**REZONING,
PLANNED UNIT DEVELOPMENT,
PLANNING APPROVAL &
SUBDIVISION STAFF REPORT****Date: September 6, 2012**

<u>NAME</u>	The Salvation Army
<u>SUBDIVISION NAME</u>	Dauphin Street Subdivision, The Army's addition to
<u>LOCATION</u>	1009 & 1023 Dauphin Street (Southeast corner of Dauphin Street and Pine Street, extending to the North side of Caroline Avenue, 120'± East of Pine Street)
<u>CITY COUNCIL DISTRICT</u>	District 2
<u>PRESENT ZONING</u>	R-1, Single-Family Residence District and B-2, Neighborhood Business District
<u>PROPOSED ZONING</u>	B-2, Neighborhood Business District
<u>AREA OF PROPERTY</u>	1 lot / 2.7 acres ±
<u>CONTEMPLATED USE</u>	Planning Approval to amend a previously approved Planning Approval to allow a parking lot expansion for an emergency shelter in a B-2, Neighborhood Business District, Planned Unit Development approval amend a previously approved Planned Unit Development to allow multiple buildings on a single building site, Zoning approval to rezone from R-1, Single-Family Residential District, and B-2, Neighborhood Business District, to B-2, Neighborhood Business District, to eliminate split zoning in a proposed commercial subdivision, and Subdivision a

SITE PLAN

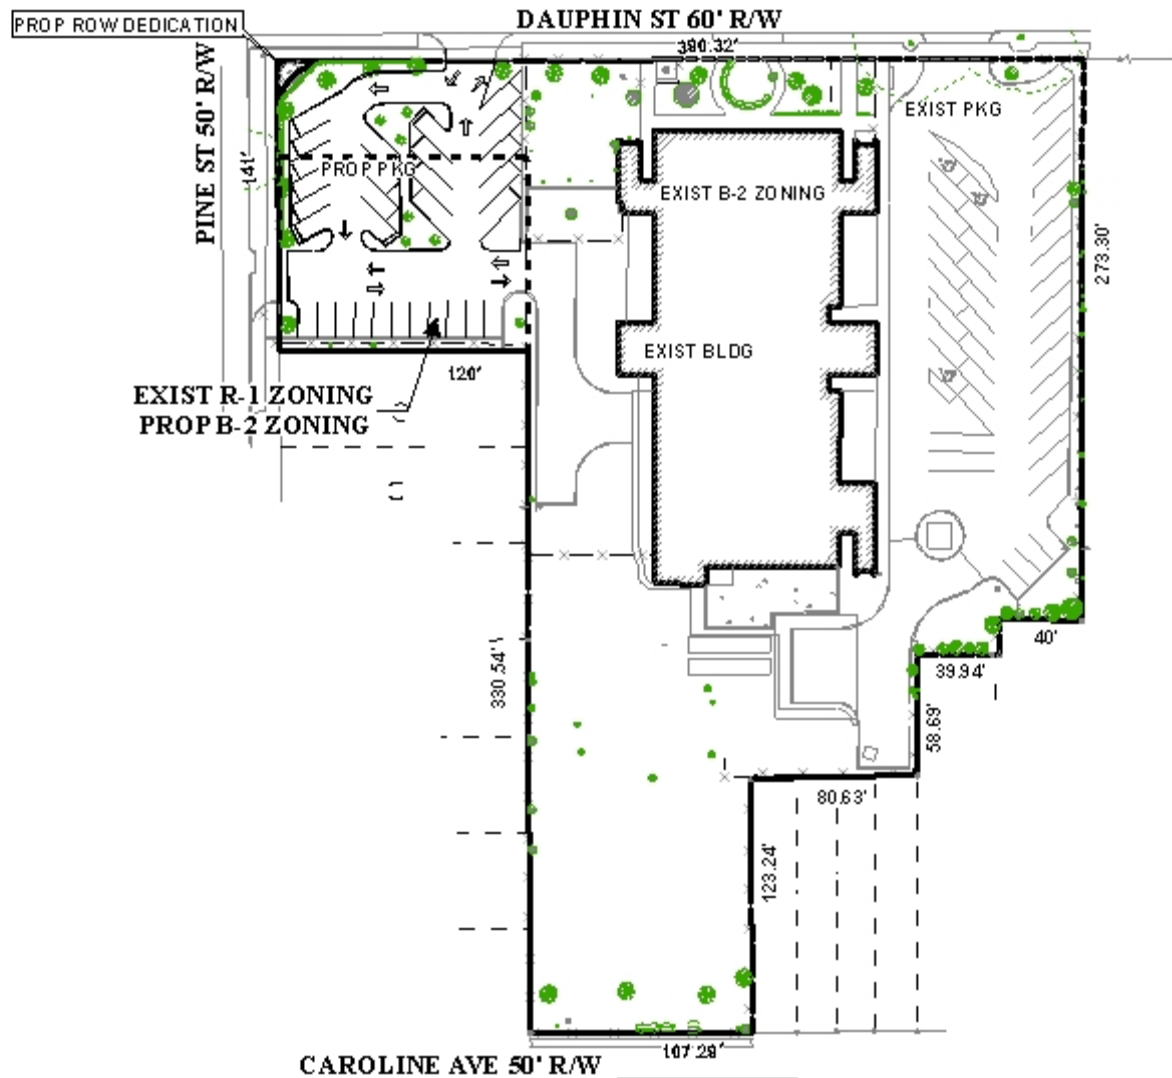
Driveway number, size, location and design to be approved by Traffic Engineering and conform to AASHTO standards. By design, the existing driveway on Dauphin Street will become one-way; the curb-cut should be modified accordingly. The width of the existing driveway on Pine Street is not illustrated, but appears to only be adequate for one-way traffic. Signage within the parking lot will be required to direct exiting traffic to Pine Street. The minimum aisle width for one-way circulation is 14'; the 13' aisle as illustrated is not acceptable.

Revised for the October 4th meeting: The western driveway on Dauphin Street has two conflict points that are of concern. The direction of the one-way aisles require a crossing movement to occur between vehicles entering and exiting the site from this driveway. Also the first two parking spaces require backing into the right-of-way at the driveway to exit the spaces. By reversing the aisle directions, both conflicts can be eliminated.

In addition to showing dedication for the corner radius of Dauphin Street and South Pine Street, the site plans should be revised to show all existing trees (with size and species) and landscape areas, including landscape area calculations. The proposed parking lot at the corner of Dauphin Street and South Pine Street does include some trees and landscape area, but it does not appear to comply with the requirements of the Zoning Ordinance, thus the site plan must be revised to depict full compliance.

Finally, the proposed parking lot appears to have a 25-foot wide curb-cut to Dauphin Street and an 11-foot curb-cut to South Pine Street. The proposed parking layout appears to be a combination of one-way and two-way circulation. It is recommended that the sub-standard curb-cut to South Pine Street be closed, and the parking lot be redesigned to provide two way access, parking and circulation only via the Dauphin Street curb-cut.

The site plan reflects the addition of trees along frontage areas, with associated calculations. The tree calculations appear to indicate that the existing trees counted for credit can possibly eliminate the need to plant any trees on the site: instead the applicant should be aware that they may be required to plant 13 trees along the Dauphin Street frontage, 4 trees along the Pine Street frontage, and 3 trees along the Caroline Avenue frontage. Existing trees in the frontage area can be counted on a one for one credit basis for a frontage tree, while existing trees in the right-of-way, if their canopies are large, can reduce the frontage length if canopies are accurately depicted on the site plan (no canopies are depicted).

The proposed parking area still has circulation issues, and also depicts an expanded curb-cut onto Pine Street to allow two way traffic. The proposed circulation at the Dauphin Street entry/exit will create crossing traffic conflict on the site, thus it is strongly recommended that the flow of traffic be reversed, and that the angled parking direction be reversed as well to eliminate the crossing traffic conflict. Also, it is recommended that access to Pine Street be eliminated in order to protect the prevailing residential uses that front Pine Street.

The revised site plan depicts a revised parking layout that eliminates the cross-access conflict, and eliminates the curb-cut onto South Pine Street. As previously stated in the applicant's narrative, there is no need for the additional parking, it is just believed to be less of a maintenance and safety issue over a landscaped area as it relates to the homeless over-nighting on the property.

- 2) Justification of the need for additional parking on the site;
- 3) Revision of the site plan to reverse the flow of traffic for the proposed parking facility to eliminate crossing conflicts on the site, and to eliminate access to Pine Street, and compliance with Traffic Engineering revised comments (*The western driveway on Dauphin Street has two conflict points that are of concern. The direction of the one-way aisles require a crossing movement to occur between vehicles entering and exiting the site from this driveway. Also the first two parking spaces require backing into the right-of-way at the driveway to exit the spaces. By reversing the aisle directions, both conflicts can be eliminated*); and

- 4) Revision of the site plan to depict 13 frontage trees along Dauphin Street, 4 along Pine Street, and 3 along Caroline Avenue, and/or depiction of tree canopies of existing street trees if they reduce applicable frontage area (thus reducing the need for new frontage trees).
